Re: Plummer Residence

In response to recent City of Mercer Island Comments with respect to protection of trees on site and those offsite that could potentially be affected by site development I have prepared the following response to the following item No. 8.

2 TREE PLAN  
 SCALE: 1/8" = 1'-0" N

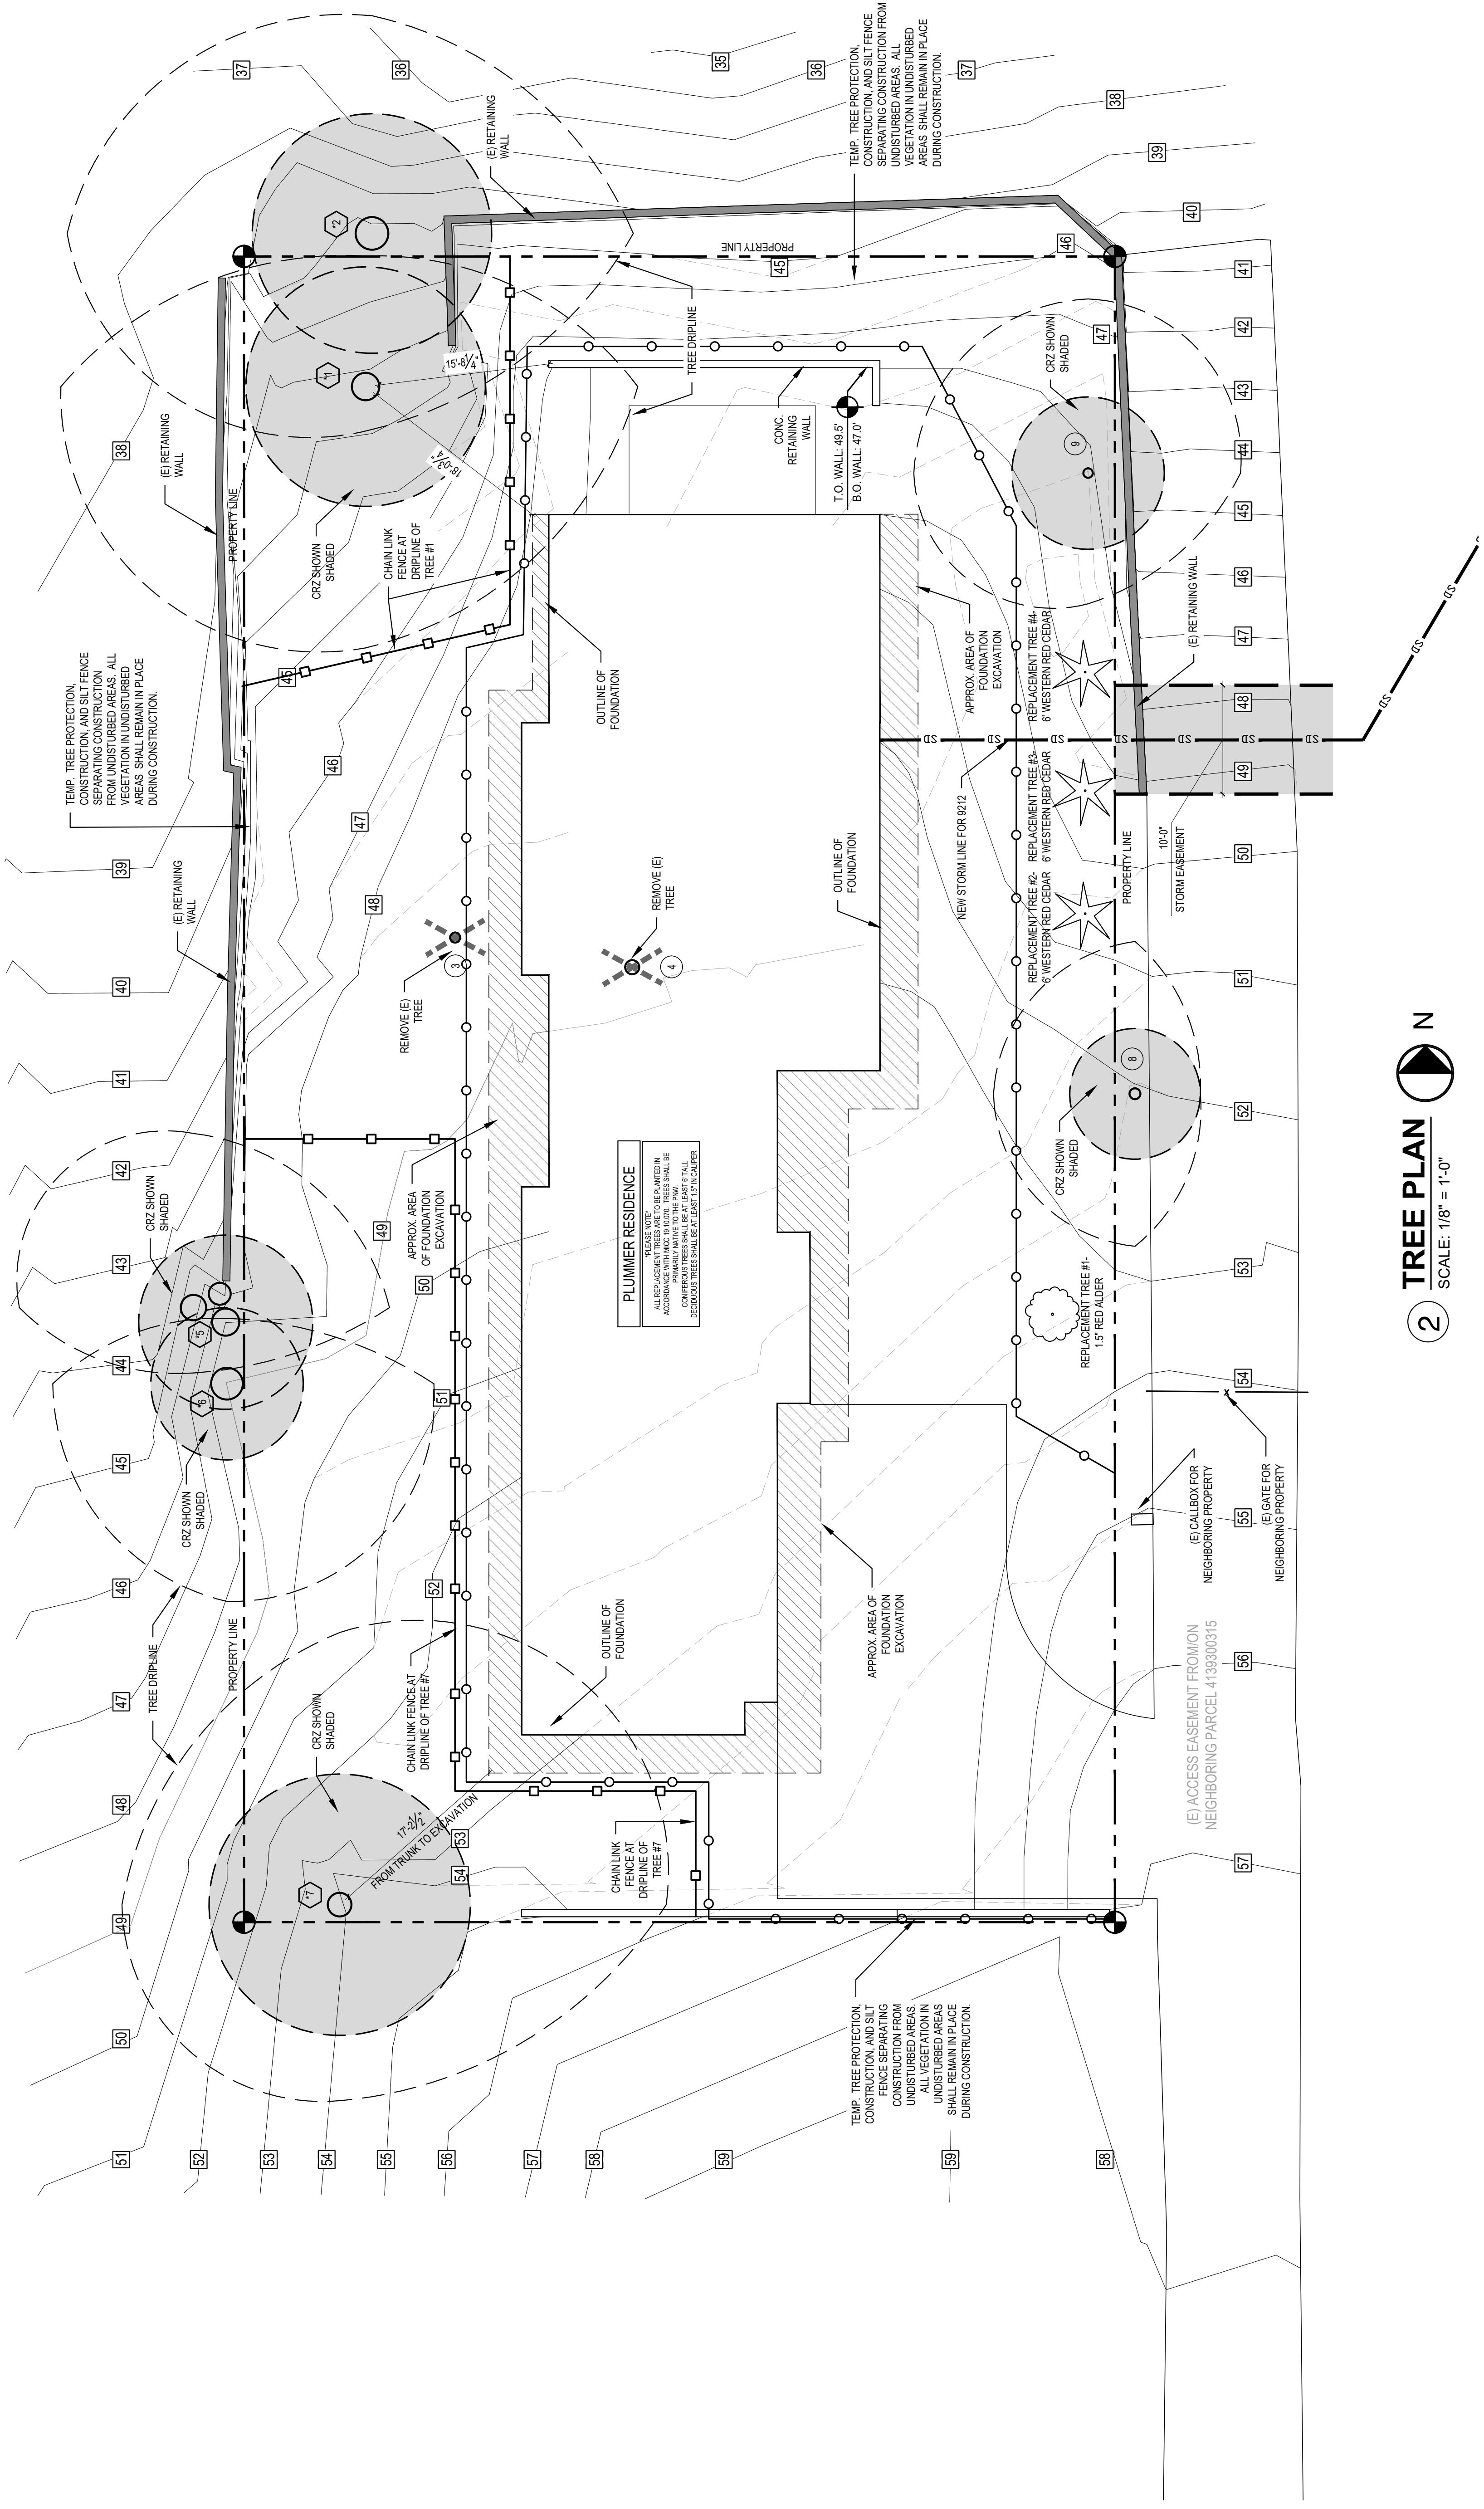
*8. (From Intake for Civil/Architect/Arborist) Grading is shown within 7' of exceptional tree 1 that has a dripline of 24'. Have the Project Arborist review and cite plan sheet C-2. Provide air excavation analysis at the location of any area of excavation within exceptional tree 1's dripline. Arborist will ensure the tree will not decline in health because of this work according to 19.10.080. Use this opportunity to excavate the to be abandoned the existing sewer, storm, water with air excavation (with air excavation). If the proposed encroachments into the dripline will damage the tree long term, those encroachments including the In-Ground Trampoline and house need to be modified or moved. Tightlining the drainage would also limit impacts to the saved trees. An Arborist memo will be required if grading and other encroachments into saved trees driplines are not moved. "*

The attached revised site plans do not propose hardscape installation near trees 5,6 or 7 or nearby offsite trees along the southwest side of the property. As well, no new sewer line installation will be run under or near trees No. 1 or 2.

Air excavation of the root zone around Tree No. 1 will be employed at the excavation line of the proposed house footing. The project arborist will be on site to inspect roots, if any encountered and will advise the contractor on proper root damage mediation including cutting the exposed roots cleanly at the excavation line, application of moist burlap over the cut ends until native soil back fill can be installed.
